**From:** Lyon, Fred  
**Sent:** Tuesday, January 07, 2014 12:43 PM  
**To:** Charles K. Johnson  
**Cc:** Banic, Merrilee  
**Subject:** RE: 10 CFR 2.206 Pre-Meeting Call and Requested Letter (G20130776; MF3031)  
**Attachments:** JLD-ISG-2013-01 Public Comments.pdf; JLD-ISG-2013-01.pdf; FSAR Table 2.4-1.doc

This document presents the U.S. Nuclear Regulatory Commission (NRC) staff's responses to comments received on the Draft interim staff guidance (ISG) document, "JLD-ISG-2013-01: Guidance for Assessment of Flooding Hazards Due to Dam Failure." The draft ISG was published in the *Federal Register* on April 25, 2013 (78 FR 24439). The public comment period closed on May 28, 2013; there were no late comments received.

**Figure 16. Hypothetical Dam Representing Storage Upstream**

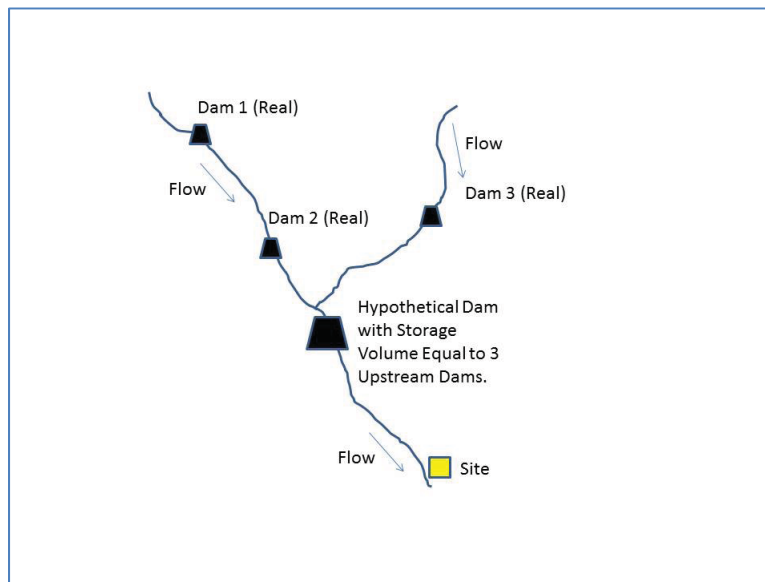
88 [J.W. Shea, TVA]	<p><b><u>Location:</u></b> 5.5/page 54</p> <p><b><u>Comment:</u></b> Figure 16 - appears to have a repeat in the last bullet</p> <p><b><u>Concern:</u></b> Editorial</p> <p><b><u>Proposed Resolution:</u></b> Remove the repeat bullet or correct the bullet if it was meant to be a 3<sup>rd</sup> point in the figure.</p>	<p><b><u>Response:</u></b> Third bullet in Figure 16 was meant to read: “Ground motions causing failure at Dam 3 cannot be excluded from causing failure at Dam 2”</p> <p><b><u>Action:</u></b> Text corrected in Figure 16.</p>
89 [J.W. Shea, TVA]	<p><b><u>Location:</u></b>5.6/page 56</p>	<p><b><u>Response:</u></b> In view of the uncertainties involved in estimating</p>
